Access Compliance Report

Public Rights-of-Way

Intersection ID: 43116	Main Street: CENTRAL_AV	Cross Street: PECAN_AV	Location: NE
ADA ID: 843343AC7BF6	Ramp Type: Perp	Initial Pass/Fail: Fail	Overall Compliance: No
Severity Score: 13.75			
Codes/Mitigation Info/Possible Solution		Field Measurements/Component Compliance

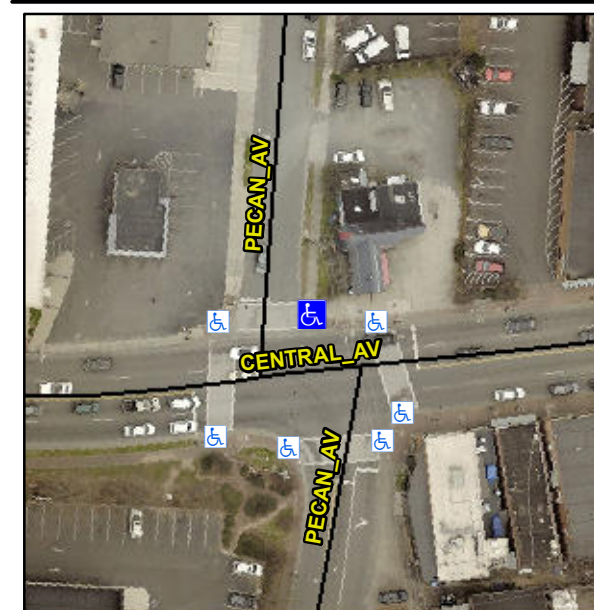
Not Found, R304.2.2, R304.5.3

Compliance	Description	Data	Compliance	Description	Data
N/A	Ramp Length (in)	63.0	No	Ramp Slope (%)	11.5
Yes	Ramp Width (in)	60.0	No	Ramp XSlope (%)	3.9
N/A	Flare Type LT	N/A	N/A	Flare Type RT	N/A
N/A	Flare Slope LT (%)	N/A	N/A	Flare Slope RT (%)	N/A
N/A	Flare Traversable LT?	N/A	N/A	Flare Traversable RT?	N/A
N/A	Landing Length (in)	N/A	N/A	DWS Provided?	N/A
N/A	Landing Width (in)	N/A	N/A	DWS Contrast?	N/A
N/A	Landing Slope (%)	N/A	N/A	DWS Length (in)	N/A
N/A	Landing X Slope (%)	N/A	N/A	DWS Full Width?	N/A
N/A	Landing Curb? (Y/N)	N/A	N/A	DWS Offset (in)	N/A
N/A	Shared Landing?	N/A			
N/A	Gutter Ponding?	N/A	N/A	Gutter Slope (%)	N/A
N/A	Gutter Lip Ht (in)	N/A	N/A	Gutter X Slope (%)	N/A
N/A	Painted X Walk1?	Yes	N/A	Painted X Walk2?	N/A
	X Walk 1 Direction	To W		X Walk 2 Direction	N/A
N/A	X Walk 1 Width (in)	143.0	N/A	X Walk 2 Width (in)	N/A
	X Walk 1 Slope (%)	0.6		X Walk 2 Slope (%)	N/A
	X Walk 1 X Slope (%)	2.5		X Walk 2 X Slope (%)	N/A

Remove & Replace Entire Ramp.
